**CITY OF PORTLAND, MAINE
DEVELOPMENT REVIEW APPLICATION
PLANNING DEPARTMENT PROCESSING FORM**

2002-0157
Application I. D. Number

Rivers Edge Subdivision Lot# 18
Project Name/Description

Approval Conditions of DRC

SITE PLAN LOT 18

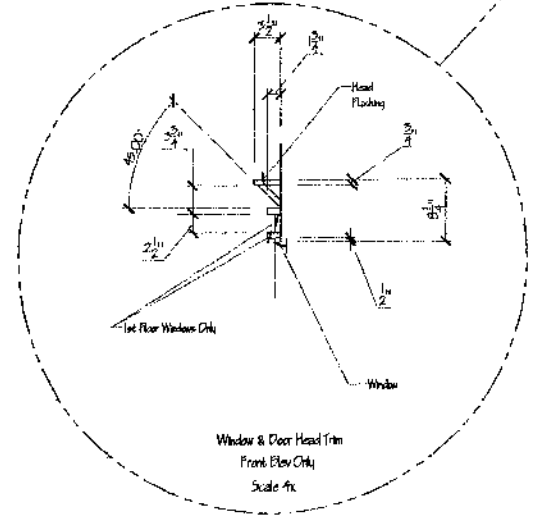
- 1 THE BUFFER ZONE MUST BE CLEARLY MARKED AND APPROPRIATE MEASURES TAKEN TO ENSURE THAT IT IS LEFT IN IT'S NATURAL CONDITION. THIS MUST BE DONE PRIOR TO CONSTRUCTION, AND VERIFIED BY THE CITY'S DRC AT THE PRE-CONSTRUCTION MEETING.

- 2 NO ADDITIONAL TREES OR VEGETATION SHALL BE DISTURBED AS A RESULT OF THE FOUNDATION DRAIN INSTALLATION.
- 3 All damage to sidewalk, curb, street, or public utilities shall be repaired to City of Portland standards prior to issuance of a Certificate of Occupancy.

- 4 Two (2) City of Portland approved species and size trees must be planted on your street frontage prior to issuance of a Certificate of Occupancy.
- 5 Your new street address is now # 111 RIVER'S EDGE DRIVE, the number must be displayed on the street frontage of your house prior to issuance of a Certificate of Occupancy.
